Change Order

PROJECT: (Name and address)
16751-Trenton High School Cafetorium

Change Order Number: 013

Miscellaneous changes per attached Change Order Proposals listed below:

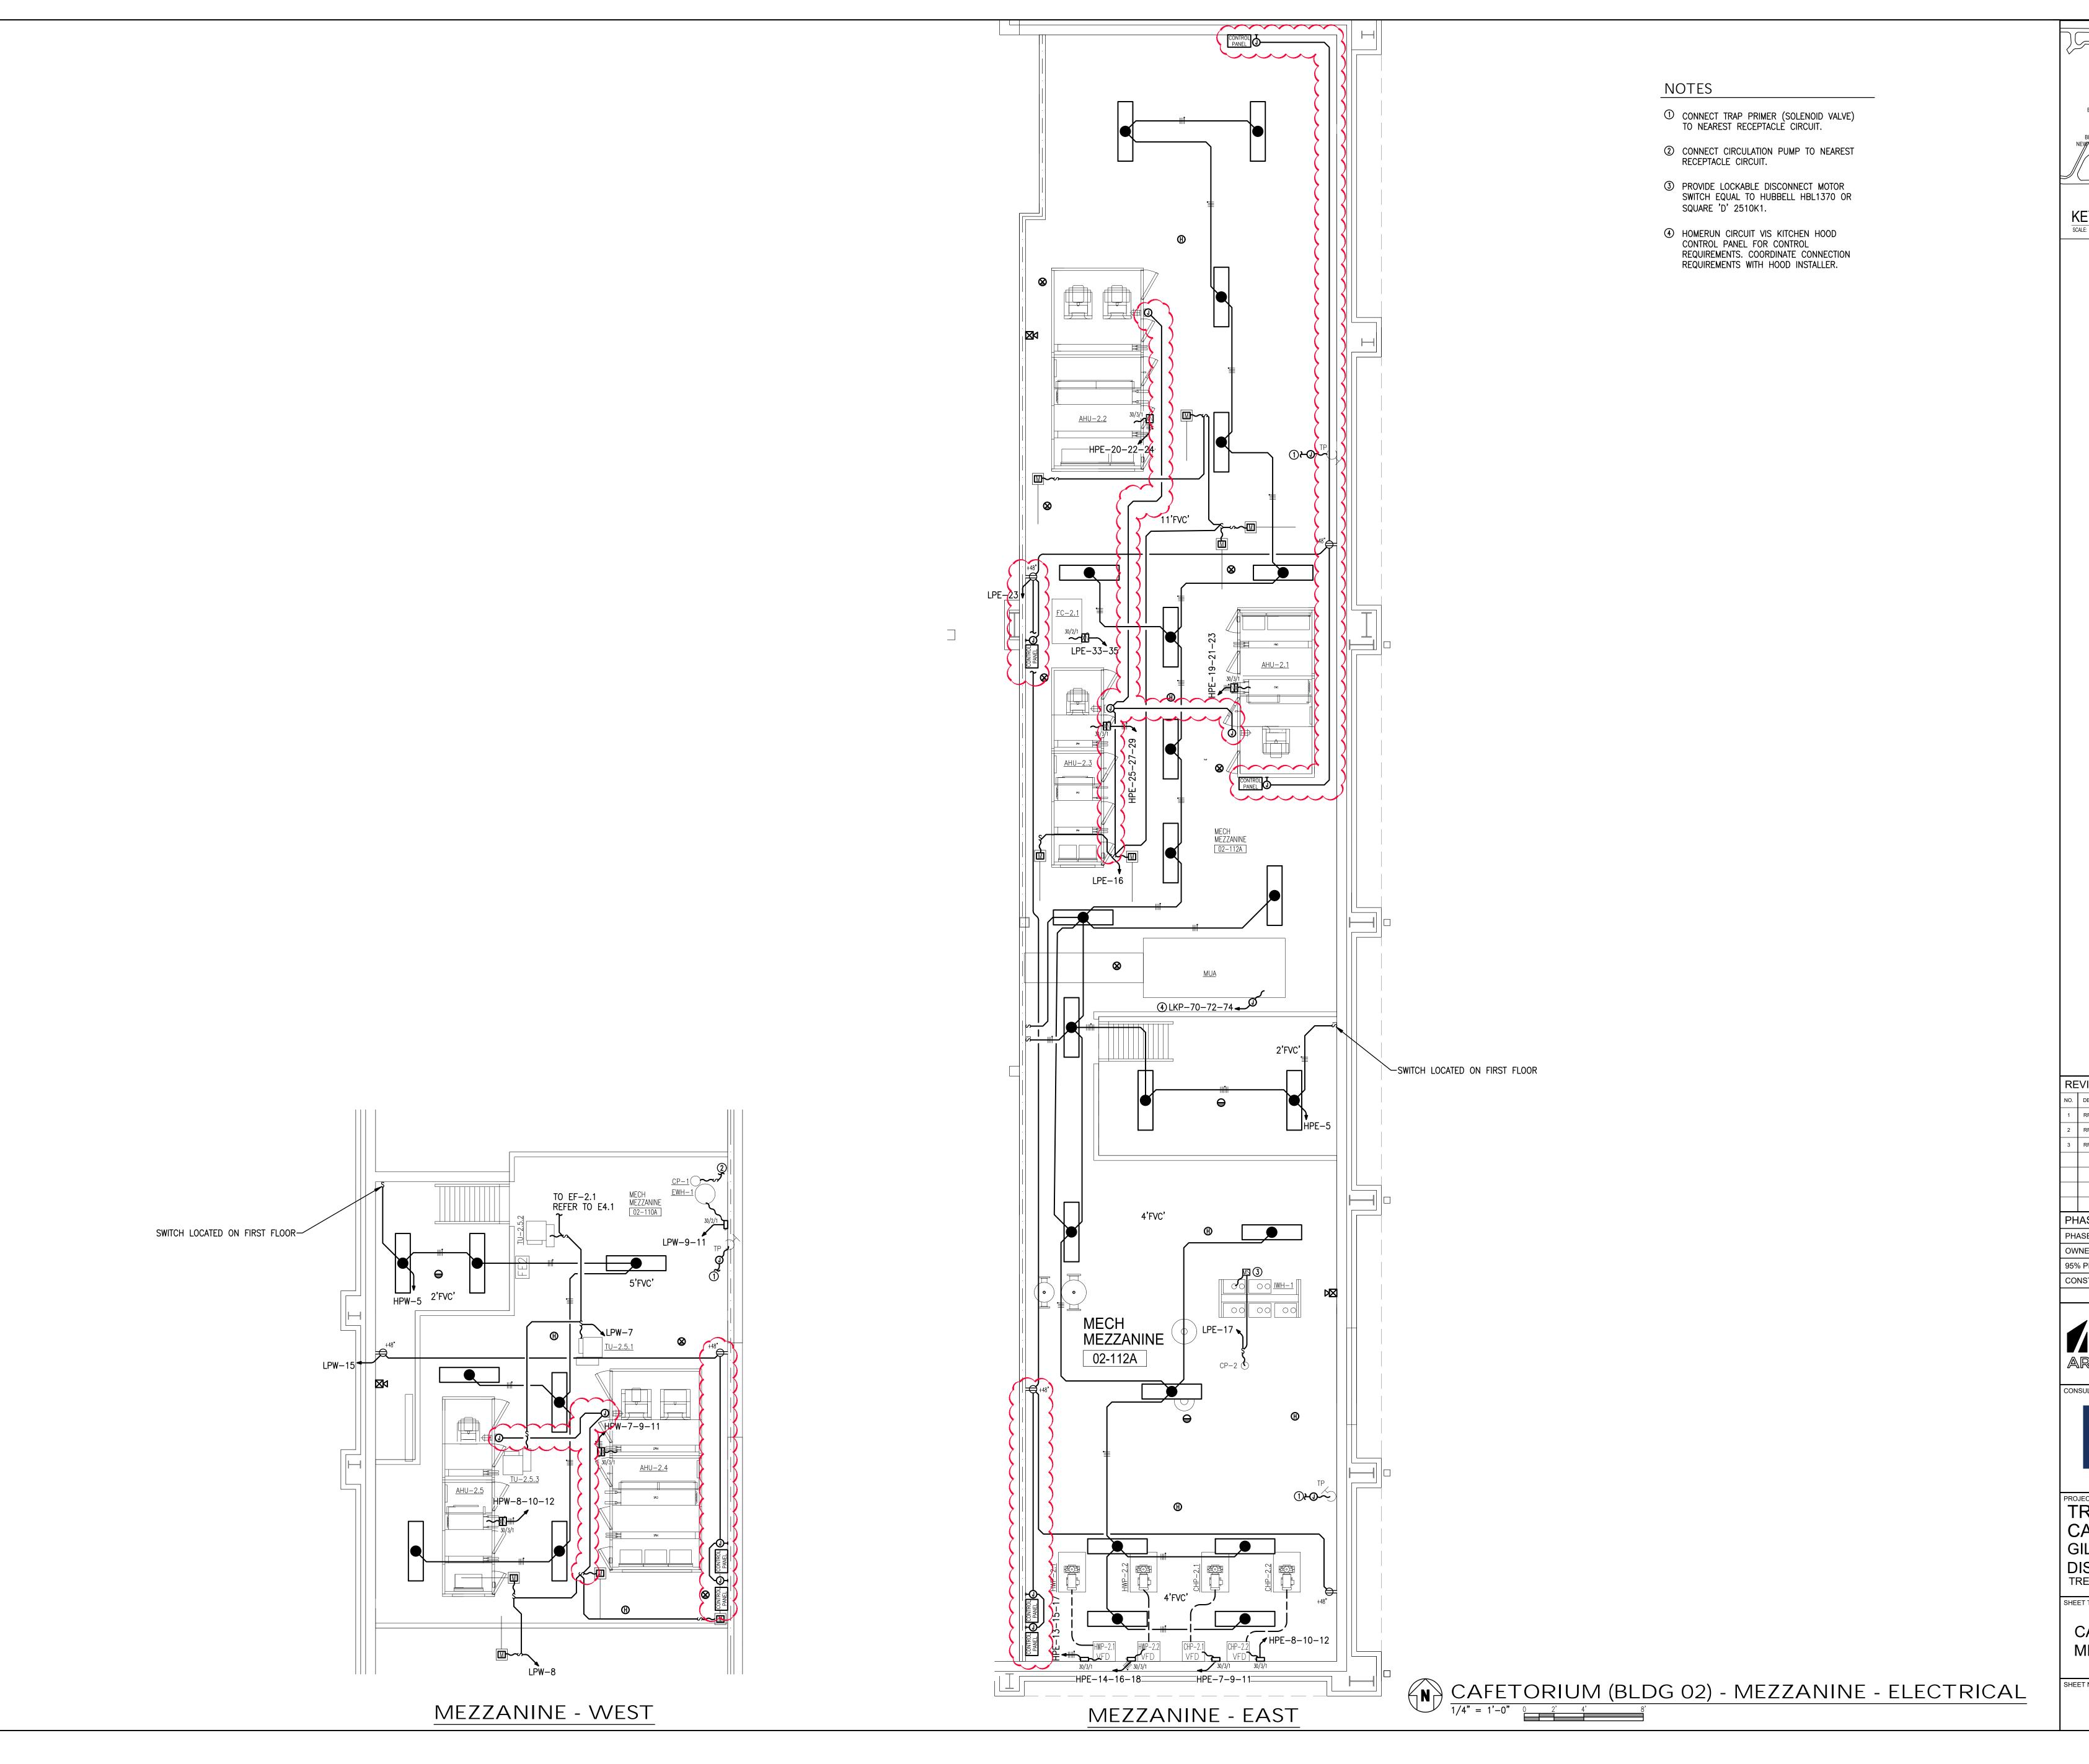
Per our conversation Yesterday, please see below & attached drawing from our electrical engineer. Please revise your change order for this work accordingly, and resubmit.

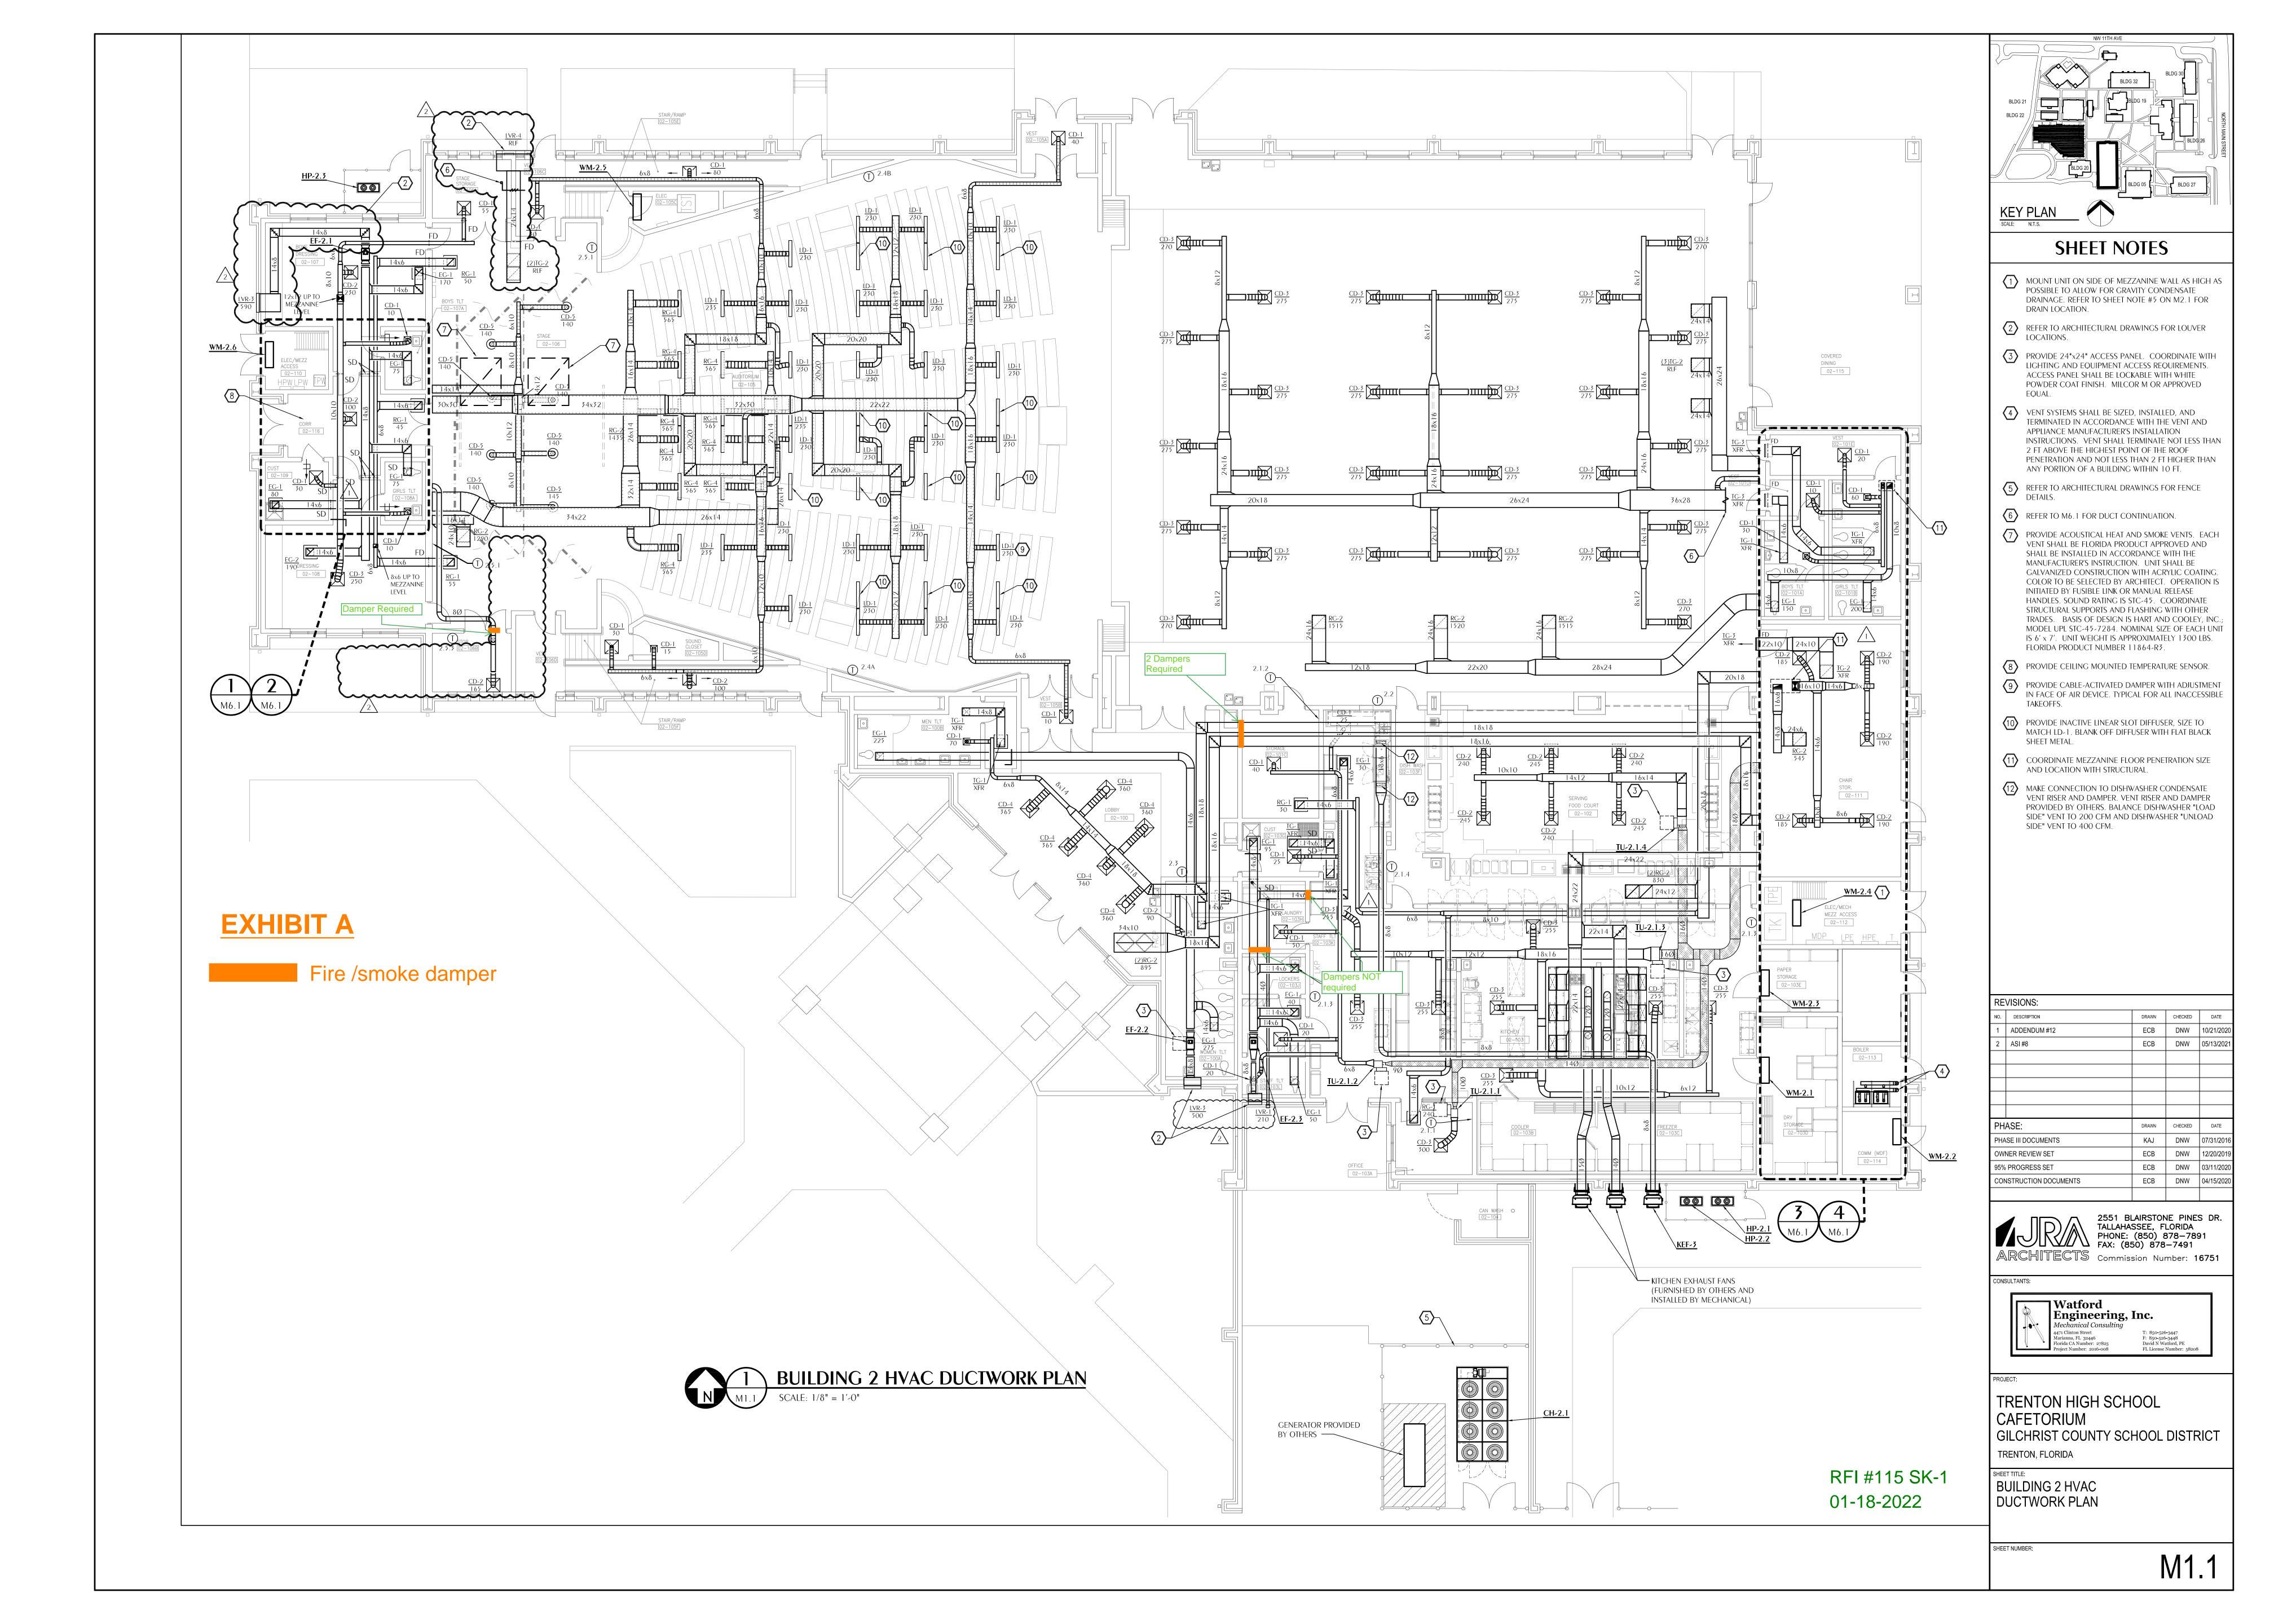
Provide Fire Dampers as indicated on the attached SK-1 (JRA's notes are in green).

Just to clarify JRA's response to RFI #115, the fire dampers are not needed at the laundry room because the room is less than 100 sf and therefore is not required to be rated. This also means that the North, East and South walls of the Laundry Room 02-103H do not have to be run all the way up to the underside of the of the roof structure. Please provide a credit for this work as part of the COP for this change.
